UNITED STATES PATENT AND TRADEMARK OFFICE

APPLICATION NO.	FILING DATE	FIRST NAMED INVENTOR	ATTORNEY DOCKET NO.	CONFIRMATION NO.
10/715,193	11/18/2003	Hong-Chi Teng	Y4P3008	3343

Office Action Summary	Application No. 10/715,193	Applicant(s) TENG, HONG-CHI	
	Examiner Nathan Danielsen	Art Unit 2627

DETAILED ACTION

FIG. 7

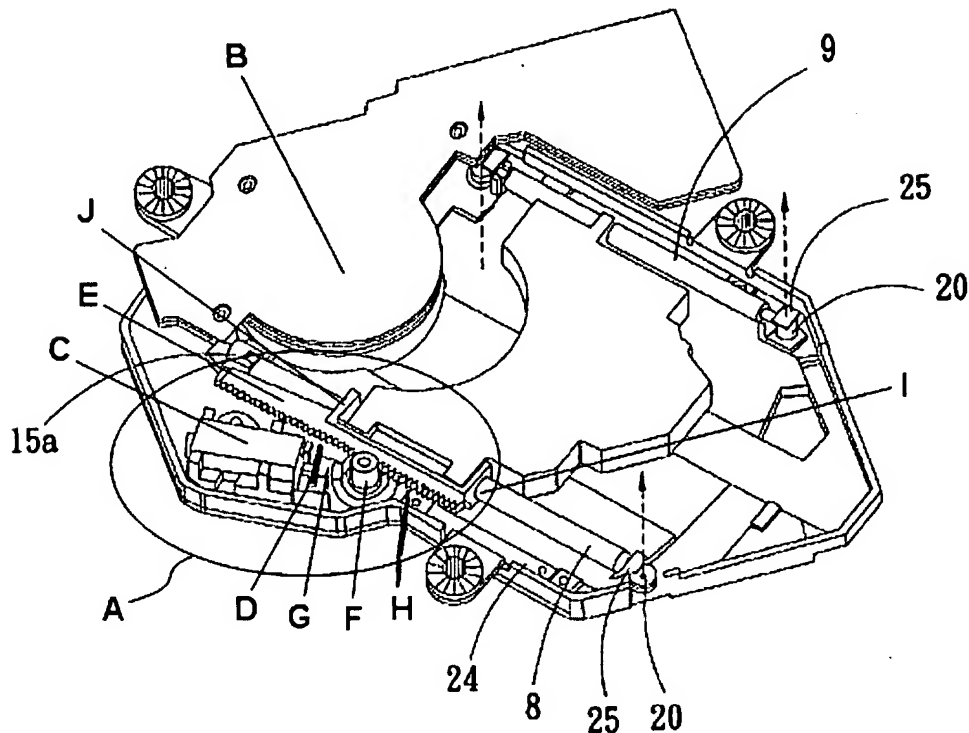
Regarding claim 6, Lu discloses a movement for disk player comprising:

a disk read head (optical pickup head 5 in figure 4);

a read head moving mechanism (element A in figure 7 as shown below); and

a disk driving motor (element B, mounted on the opposite side of the line, in figure 7);

wherein said moving mechanism comprising a driving source (element C in figure 7), a

first gear coupled to said driving source (element D in figure 7), a first rail

(principle guide rod 8 in figure 7) and a second rail (secondary guide rod 9 in

figure 7), a rack mounted on said first rail (element E in figure 7), and a second

gear (element F in figure 7) meshed between said first gear and said rack; and

the second gear is in contact with a spindle of the first gear (element G in figure 7);

wherein one lateral side of said rack has a plurality of teeth (element H in figure 7); said

teeth of the rack is engaged to said second gear; and another side of said rack

having two holes (elements I and J in figure 7); said first rail inserts into said two

holes, thereby, rotation of said second gear will drive the rack and thus drive the

first rail; said first rail is engaged to the driving head (see figure 7 below for all limitations not explicitly labeled).
